UNITED STATES NUCLEAR REGULATORY COMMISSION WASHINGTON, D. C. 20555

FACILITY: Joseph M. Farley Nuclear Plant Unit No. 2

SUBJECT: SUMMARY OF JULY 9, 1980 MEETING REGARDING REVIEW OF

OPERATING LICENSE APPLICATION

H2 - O2 - N2 MIXTURES OF FLAMMABILITY Figur 4.11.3

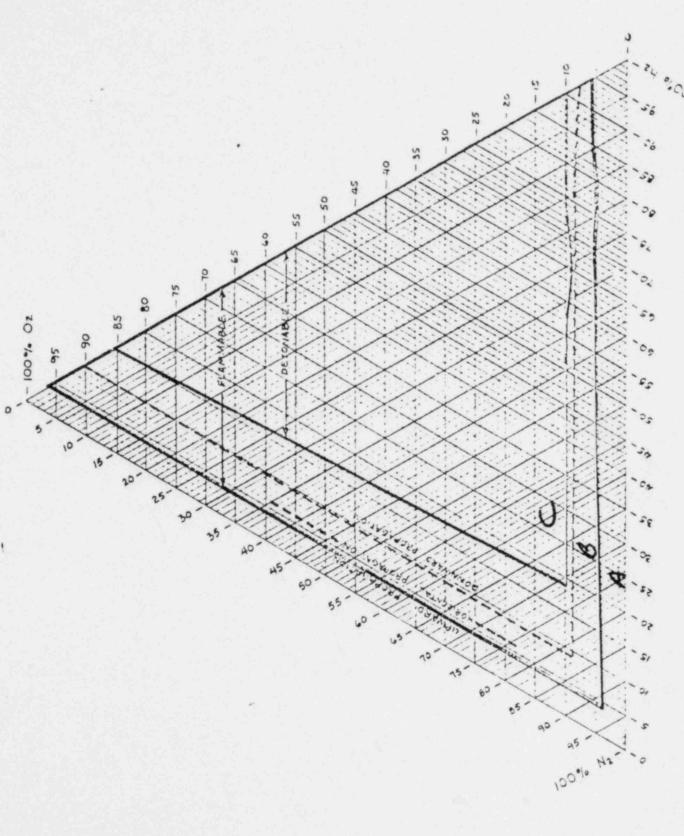
APCo showed NRC a triaxial graph of explosive flammable mixtures of H_2 , O_2 and N_2 . APCo will document the accuracy of the graph. The graph will then be considered by NRC as a basis for setting H_2 and O_2 tech spec limits. This revised specification and appropriate documentation will be submitted to NRC by APCo.

3.11.2.5 The concentration of oxygen in the GASEOUS RADWASTE SYSTEM shall be limited to less than or equal to the by volume: region A of Figure 4.11.3

**Concentration
- b. With the concentration of oxygen in the GASEOUS RADWASTE SYSTEM in region C growth than 48 by volume, immediately suspend all additions of waste gases to the system and reduce the concentration of oxygen to waste gases to the system and reduce the concentration of oxygen to waste gases to the system and reduce the concentration of oxygen to waste gases to the system and reduce the concentration of oxygen to waste gases to the system and reduce the concentration of oxygen to waste gases to the system and reduce the concentration of oxygen to waste gases to the system and reduce the concentration of oxygen to waste gases to the system and reduce the concentration of oxygen to waste gases.
 - c. The provisions of Specifications 3.0.3 and 3.0.4 are not applicable.
